ADDENDUM #1

May 4, 2011

Re: Harrisburg Area Community College
Goodling Building Classrooms & Computer Lab Renovations
Solicitation # 11-19

From: Eastern PCM, LLC
Construction Manager – HACC
645 N. 12th Street, Suite 200
Lemoyne, PA 17043

1 ENLARGED PLAN - COMPUTER LABS
SCALE: N.T.S

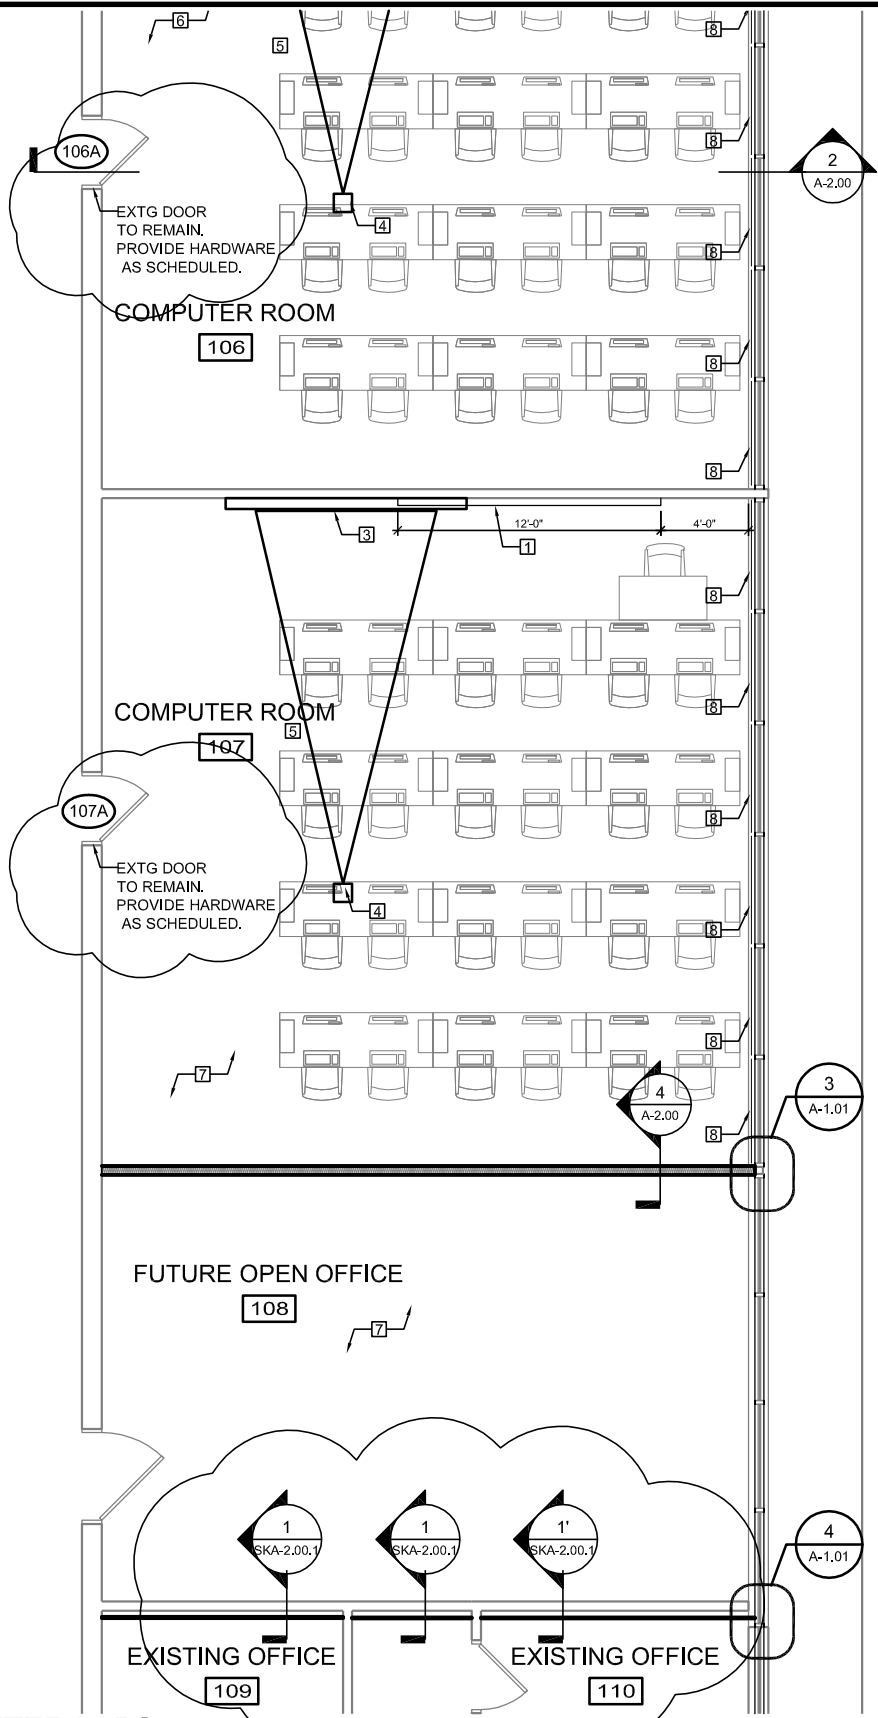
A. Drawing A1.01 – Enlarged Floor Plan

REVISE as follows:

- a. Designate the separated space west of Computer Room 107 as Future Open Office 108
- b. Designate the separated space west and toward the northern corner of Future Open Office 108 as Existing Office 109
- c. Designate the separated space west and toward the southern corner of Future Open Office 108 as Existing Office 110
- d. Add wall section flag thru improved east wall of Existing Office 109 designated 1 and refer to attached Sketch skA-2.00.1 for its construction.
- e. Add wall section flag thru improved east wall of Existing Office 110 designated 1' and refer to attached Sketch skA-2.00.1 for its construction.
- f. Expand Note 4 concerning the drop post projector mount. "HACC will furnish the mounting assembly (in accordance with the product data attached to this Addendum) for installation and connection by the Contractor."

D-1.00

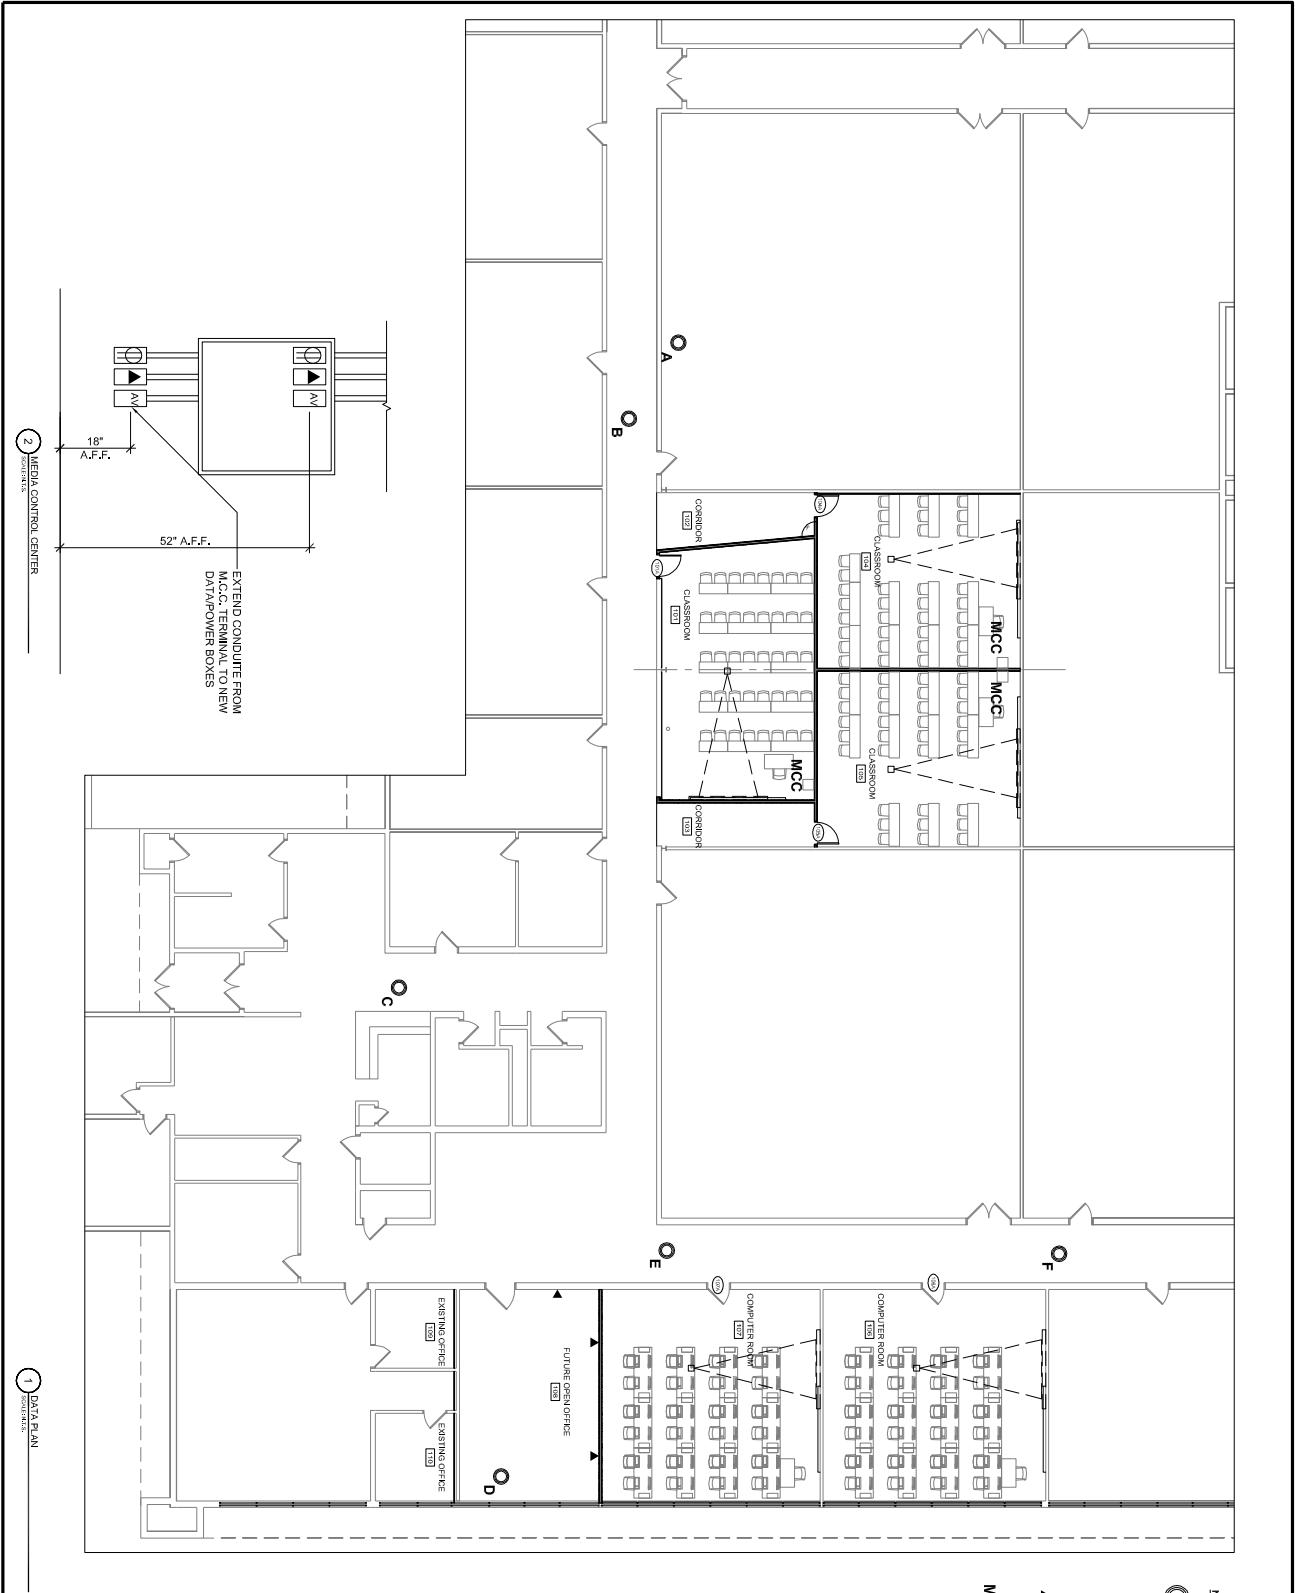
D. Drawing D-1.00 – Data Plan

ADD Drawing D-1.00 – Data Plan, Attached
